Green Infrastructure Appeal Statement

Application No.	252762
Appeal Reference:	APP/6011060
Appeal Site:	West Court Land, Park Lane, Finchampstead, Wokingham, RG40 4QF
Proposal:	Prior approval submission for a proposed installation of replacement electronic communications apparatus comprising a slimline lattice mast, 3 no. aerials, 2 no. transmission dishes, 1 no. GPS aerial, radio equipment housing and development ancillary to radio equipment housing.

- 6.7 With regards to the visual impact of the mast on the SANG footpaths, I have included below the photo submitted by the appellant in Appendix 1 of the Appeal Statement (doc ref: APP - Appendix 1 Photos with mast), titled "View 1 – from north of the mast on SANG footpath".

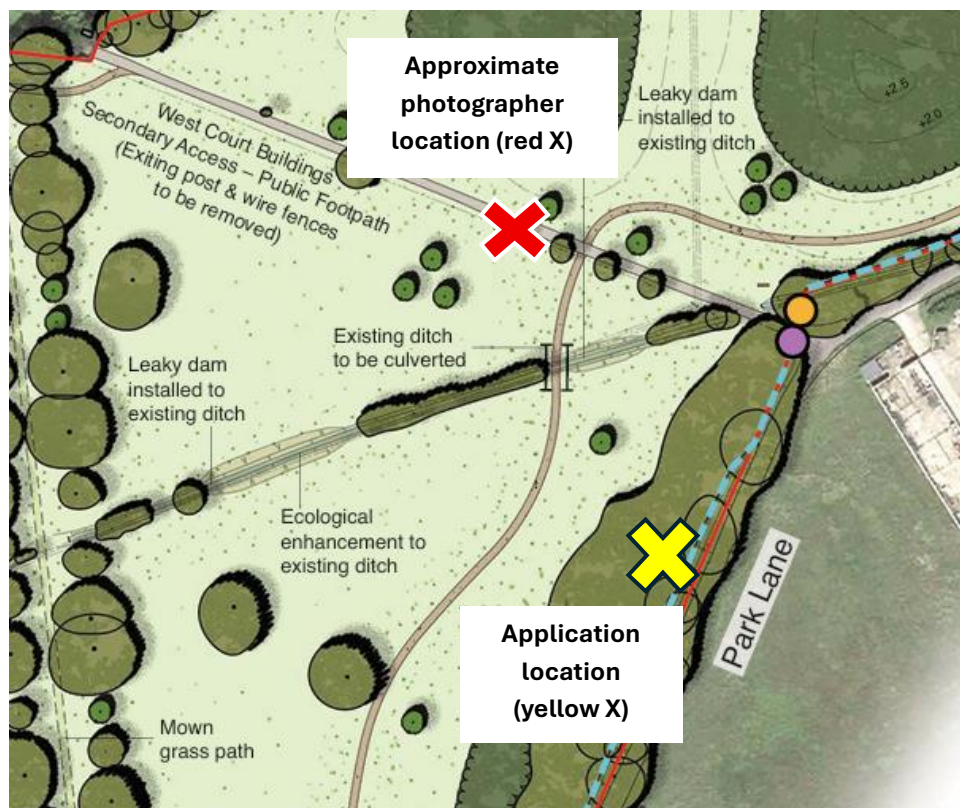
- 6.8 This photograph is not taken from the closest footpath to the mast, which I have marked in red on the photograph. It also places a standard planted tree in the foreground, blocking any visible elements of the base structure from this particular angle. This photograph represents a single viewpoint from within the SANG but does not demonstrate the view of the mast and base structure from the closer path, or other positions within the SANG to the north or immediate west of the proposed structure. It does also not appear to account for any proposed loss of trees.

- 6.9 The absence of an arboricultural survey stating the heights of the neighbouring trees means it is difficult to ascertain if the height of the mast shown in the above photograph is reflective of its true scale.

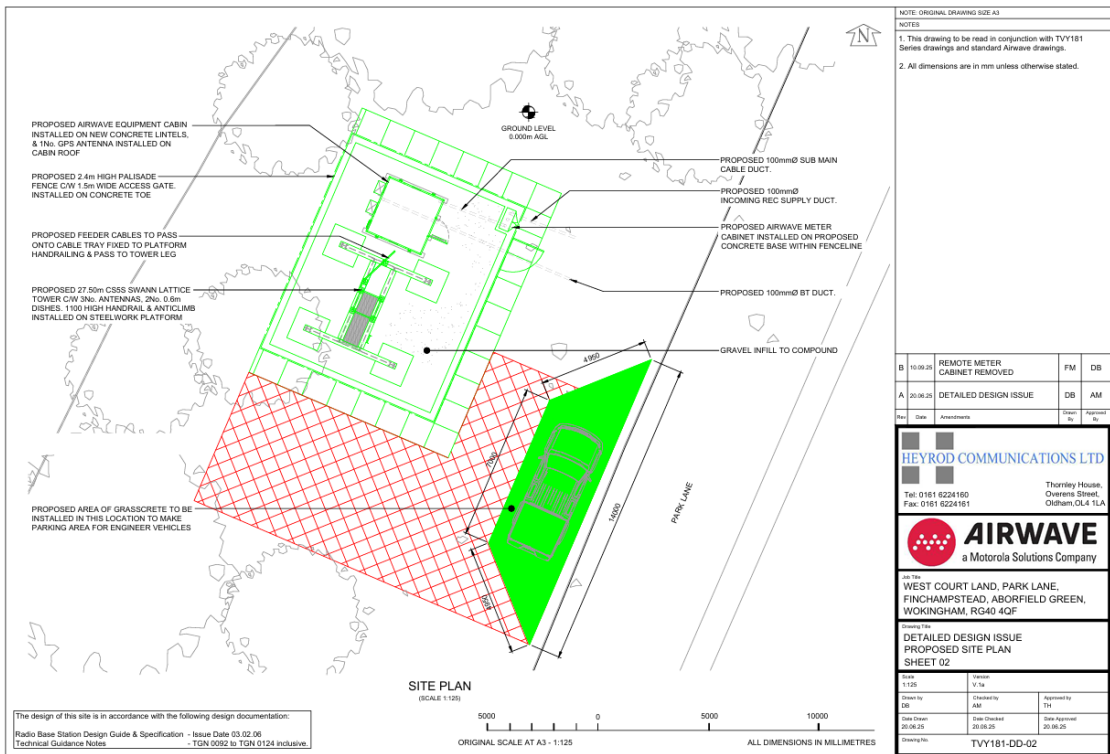
6.11 The photograph below (taken in November 2025), shows the view of the application site from the closest section of footpath. From this point of the site, and along the rest of this stretch of footpath, not only would the mast be much more visible and imposing, but the base structure and palisade fencing would be extremely prominent.

Doc ref TVY181 Proposed Site Elevation

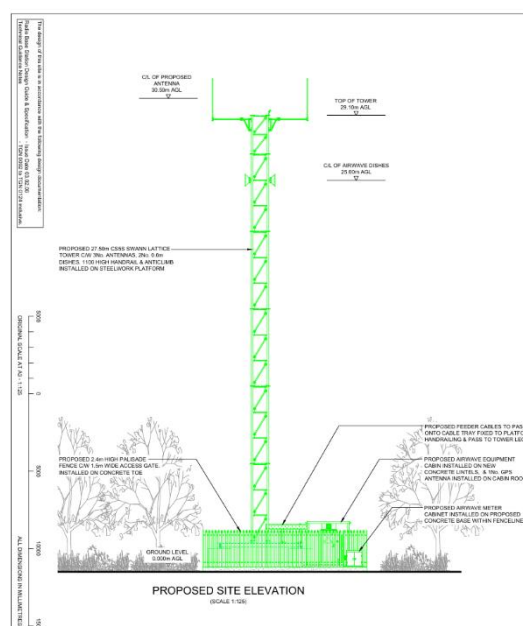
6.13 Below are the photos and proposed site elevation plan supplied by the appellant, which show existing examples of the proposed mast and base structure and the relative size. I have included these here to highlight the contrast between the semi-natural environment and ecologically important hedgerow/trees and the highly urban and artificial proposed structure.
